RE: 1618 N. Roosevelt Blvd #TP2022-0012
(Final Landscape Plan Review)

FROM: Karen DeMaria, City of Key West Urban Forestry Manager

RE: 1618 North Roosevelt Blvd (Landscape Sec 108 Review)

RE: **1618 N. Roosevelt Blvd (permit application #TP2022-0010)**

LANDSCAPE PLAN PROPOSAL OVERALL
SCALE: 1/20" = 1'-0"

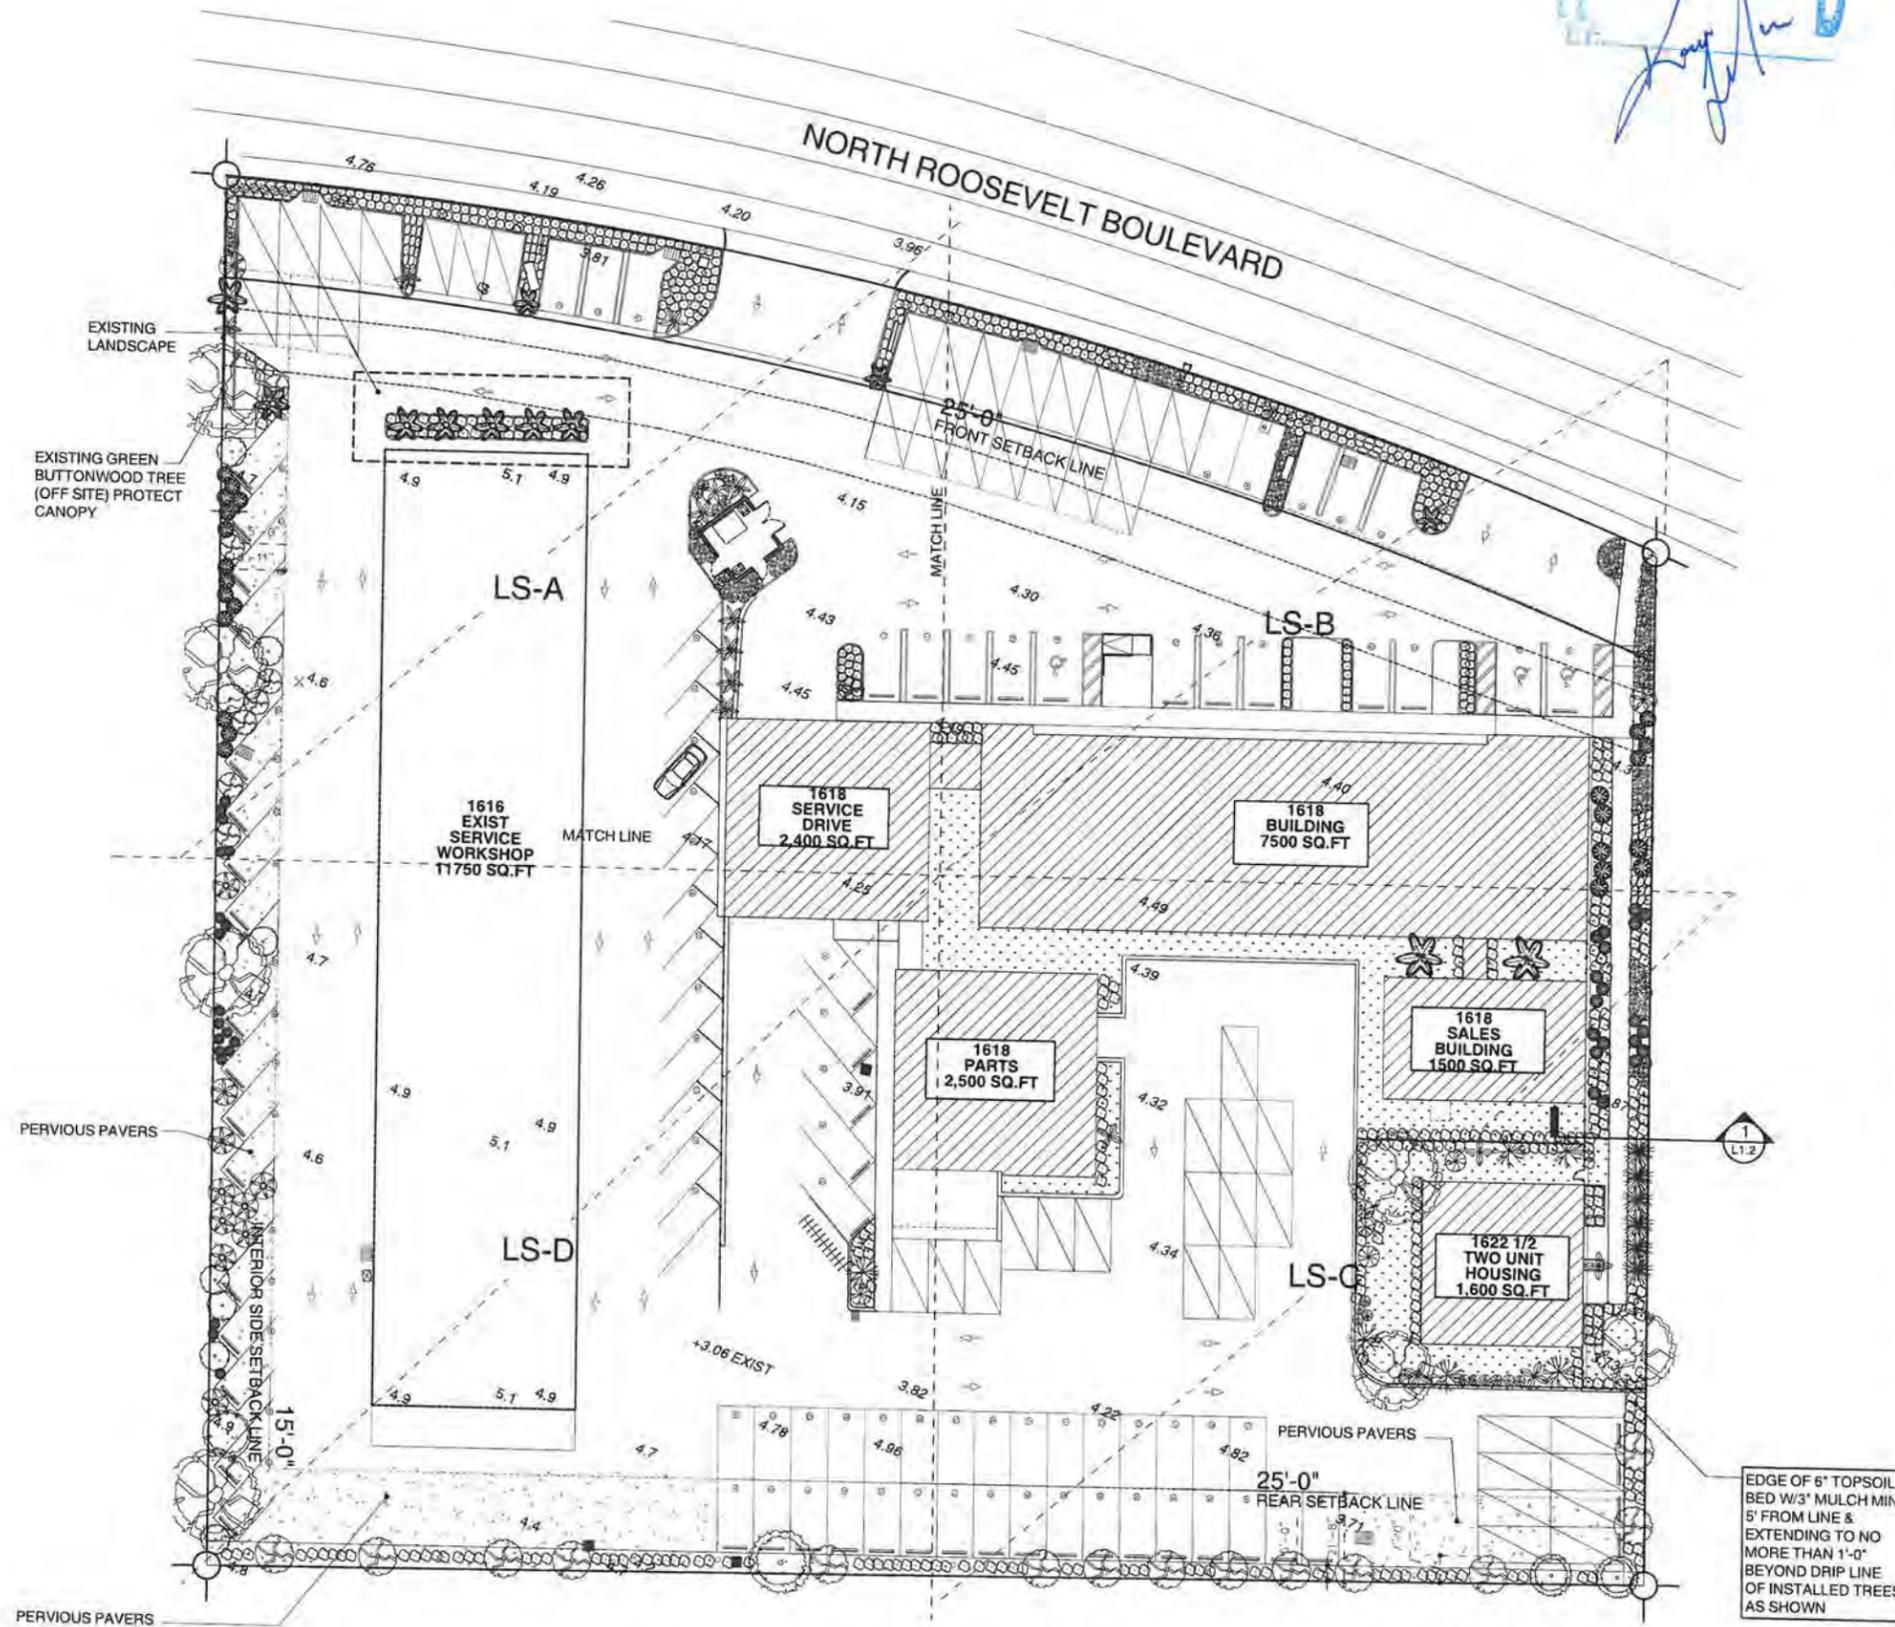
The east side buffer is approximately 5 ft wide therefore, 72 plant units per 100 linear feet are required for a total of 267 plant units. The plan proposes a total of 167 plant units. **Waiver required or add additional plants to the plan.** There is a sidewalk immediately adjacent to this buffer area with approximately an additional 80 shrubs being planted.

The south side buffer is approximately 5 ft wide therefore, 72 plant units per 100 linear feet are required for a total of 267 plant units. Three existing Strangler Fig trees are located in this buffer area and are to remain. Strangler Fig trees are an important canopy tree therefore, as per Sec 108-451, a two tree credit for each Strangler Fig tree has been given. The plan proposes a total of 251 plant units. **Waiver required or add additional plants to the plan.**

The west side buffer is approximately 2.5 ft wide therefore, 80 plant units per 100 linear feet are required for a total of 278 plant units. The plan proposes a total of 255 plant units. **Waiver required or add additional plants to the plan.**

7. 108-413, landscape requirement along street frontages. The property is 2.76 acres therefore, this section of the code requires 120 plant units per 100 linear ft in a 30 ft wide buffer area for a total of 464 plant units. The plan proposes approximately 260 shrubs planted in a 5 ft wide landscape strip along the N. Roosevelt Blvd sidewalk. The proposed landscaping also includes several island extension areas from the shrub landscape strip that include an additional 150 plants units that include shrubs and five palms. **A waiver is needed for buffer width and plant units.**

16. Sec 108-515: Irrigation plan required. An irrigation plan has not been submitted. A note on the landscape plans states; "all areas to be irrigated w/drip irrigation only system (by others) to be included in permit." **A condition of the approval is needed.**

1. Due to the rush review of the submitted landscape plan, final approval of a corrected and updated landscape plan is required from the Tree Commission to include additional plantings, as requested by the Planning Director, and Urban Forestry Manager.
2. An irrigation plan is required prior to placement on City Commission agenda.
3. A landscape maintenance plan and palm transplantation plan is required.

EXISTING LANDSCAPE & TREE PROTECTION PLAN
 SCALE: 1"=20'-0"

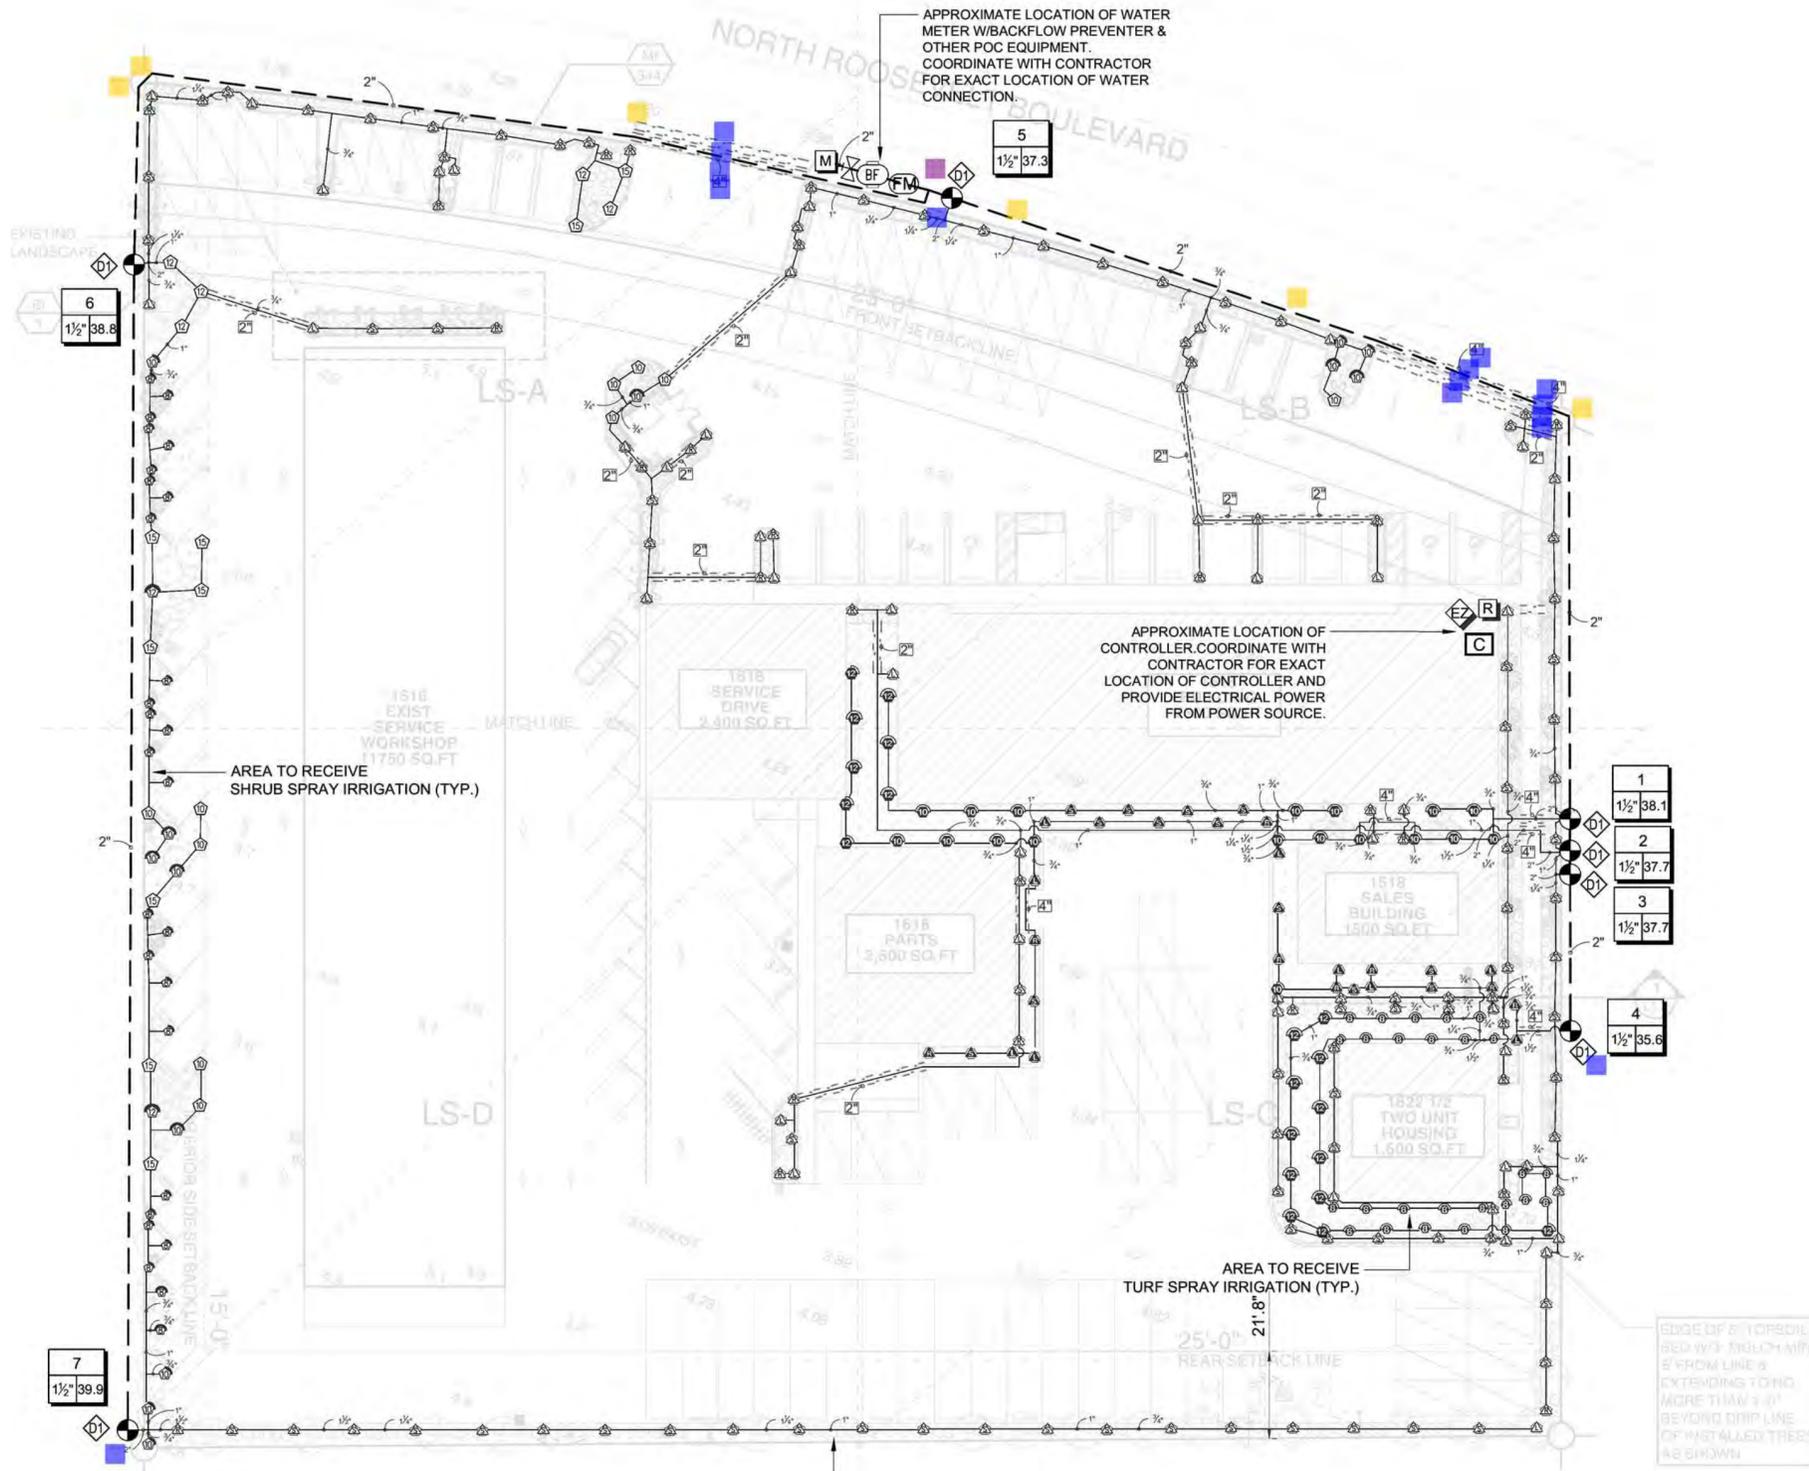
The existing site map shows all the documented vegetation on the property. The plan misidentifies the scientific name on a few species. This will need to be corrected prior to Final Landscape Plan review by the Tree Commission.

No regulated trees or palms are being removed. Nine Royal Palms will be relocated on the property. A transplant plan will need to be provided.

LANDSCAPE PLAN PROPOSAL OVERALL
SCALE: 1/20" = 1'-0"

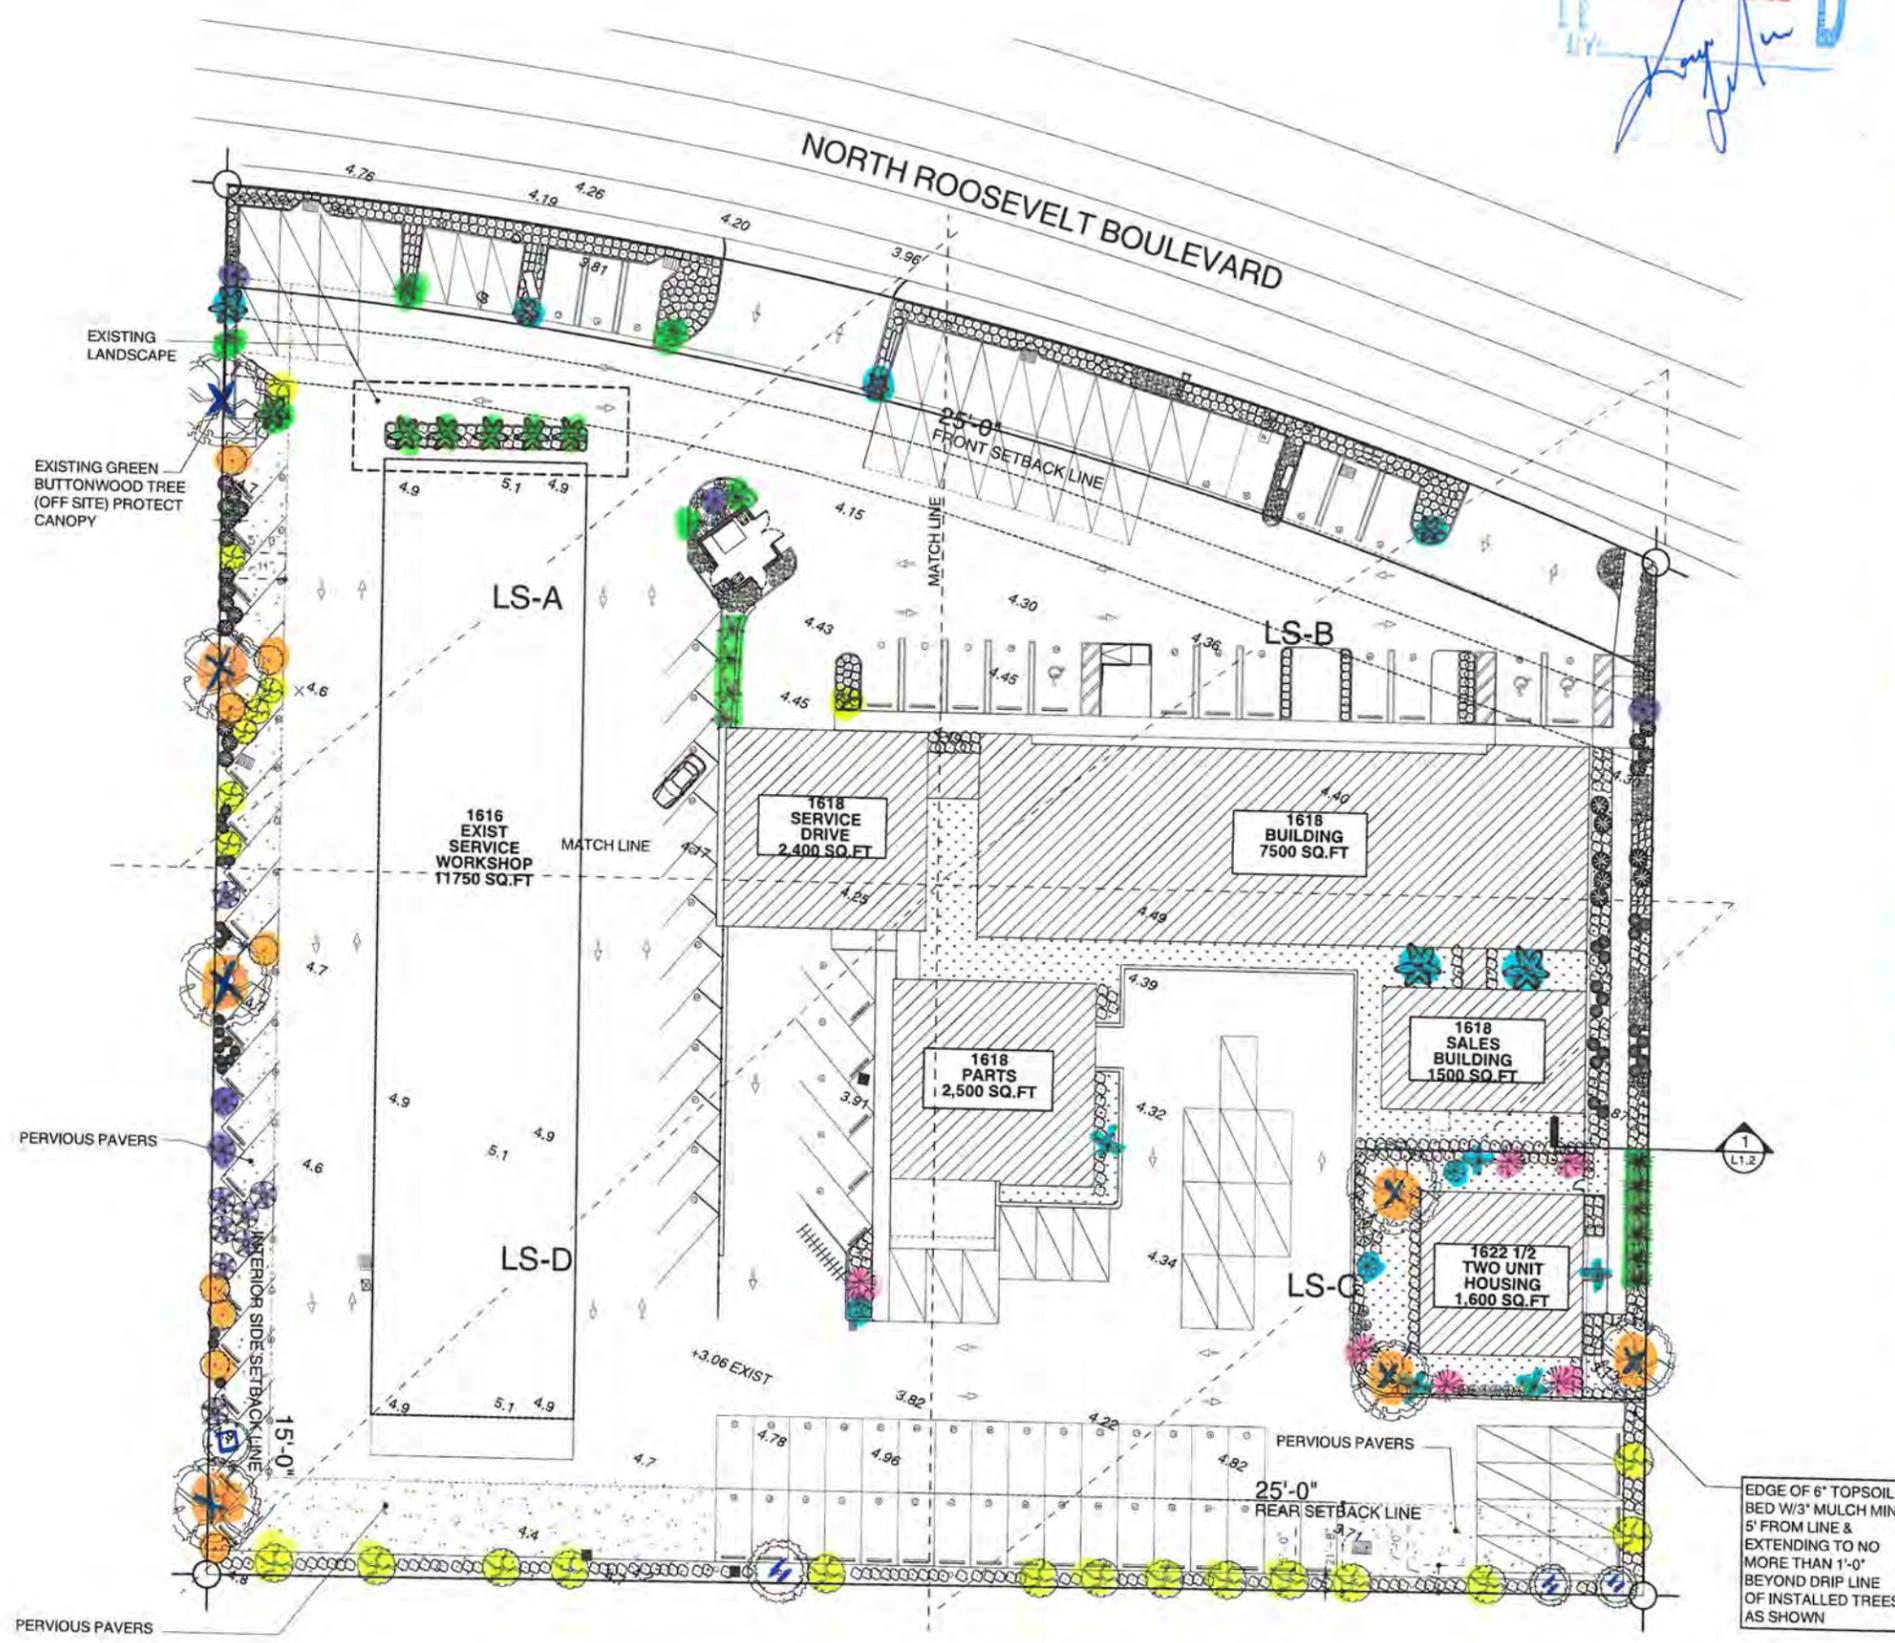
An application was submitted for Final Landscape Plan Approval for the above referenced property also known as Keys Auto Center. There is no tree removal involved with this review but, several palms will be transplanted.

The property is an existing car dealership/auto repair facility that is being redeveloped. The Final Landscape Plan will enhance the existing area and includes additional trees around the property line buffer areas and around the two new residential units. Nine existing Royal Palms and (6) young Bismarkia palms will be transplanted to other areas of the property. The new landscaping is 70% native vegetation. An irrigation and landscape maintenance plan has been submitted. A transplantation plan must be submitted prior to issuance of any building permits.
